PCN / EOL Notification

Product Change Notification Number: RC080902

Title: AT91SAM9261S Revision and Ordering Code Change

Top side marking:

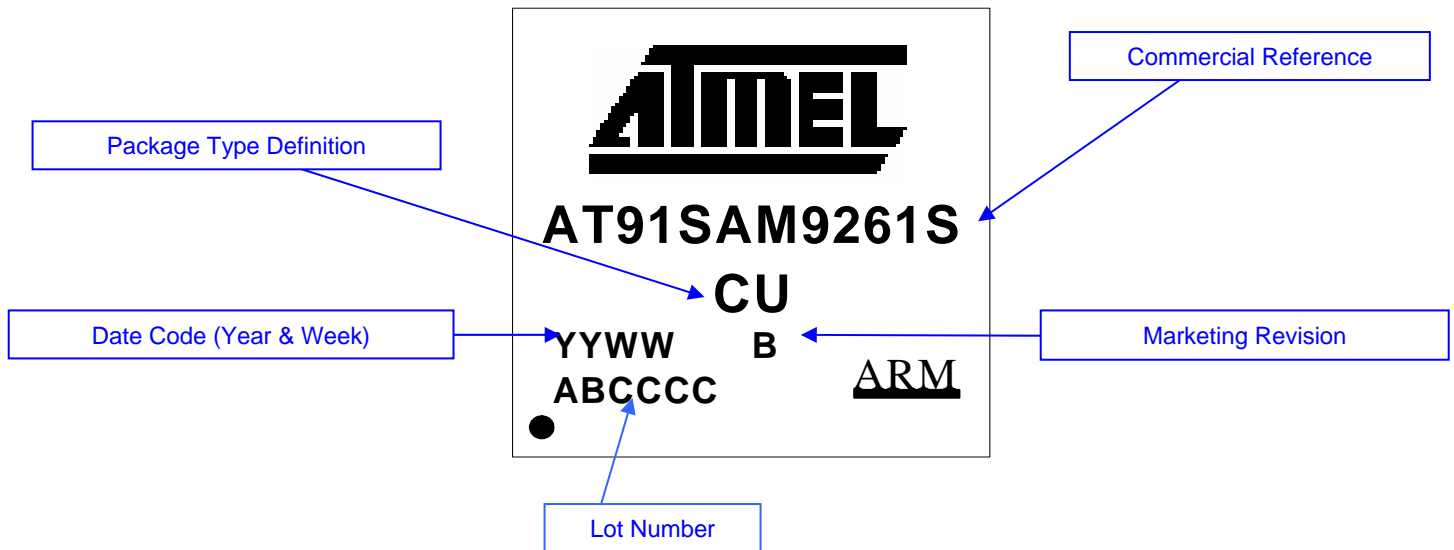
Marketing Revision B ordering code: AT91SAM9261SB-CU

Marketing Revision on the topside marking will be incremented from A to B.

Chip-ID: AT91SAM9261S Revision B chip ID is: 0x019703A1
